SUBJECT: KINGSTON STEAM PLANT - ANNUAL JOINT POWER ENGINEERING AND FOSSIL AND HYDRO
POWER INSPECTION OF THE ASH DISPOSAL AREA

INSPECTION OF
KINGSTON STEAM PLANT
ASH DISPOSAL AREAS

TITLE KINGSTON STEAM PLANT - ALL UNITS - ANNUAL JOINT INSPECTION BY THE DIVISION OF POWER ENGINEERING AND CONSTRUCTION AND THE DIVISION OF FOSSIL AND HYDRO POWER		REPORT NO. FEP-ASH-87-6	
		PLANT/UNIT	
		SAR SECTIONS	
VENDOR	CONTRACT NO.	KEY NOUNS	UNID SYSTEM(S)
	REV	(FOR RIMS USE)	RIMS ACCESSION NUMBER
	R0		B65 '87 0528 001
APPLICABLE DESIGN DOCUMENTS	R1		
	R2		
REFERENCES	R3		
	R4

SUBJECT: KINGSTON STEAM PLANT - ANNUAL ASH DISPOSAL AREA INSPECTION

- ② CONSTRUCTED WETLAND
AT BASE OF SOUTHEAST
DIKE.

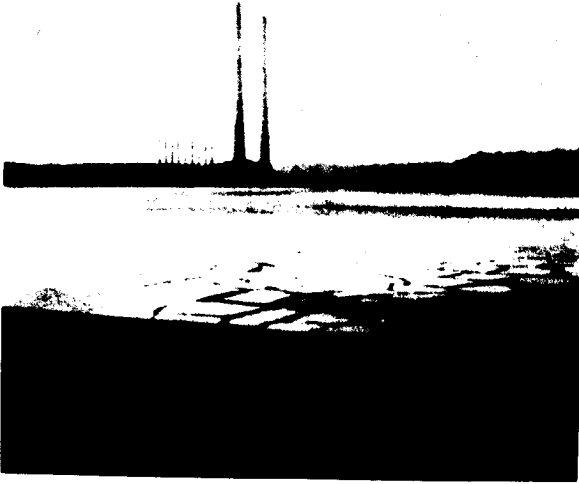
2.2 Seepage of redwater still persists along the exterior slope of the southeast dike near its southern boundary. The majority of the redwater drainage in this area of the disposal area is collected in an interceptor ditch and routed to an engineered wetland for treatment before discharging into the intake channel. The wetland consists of several shallow ponds with cattails and is located as shown on the attached drawing 10W420.
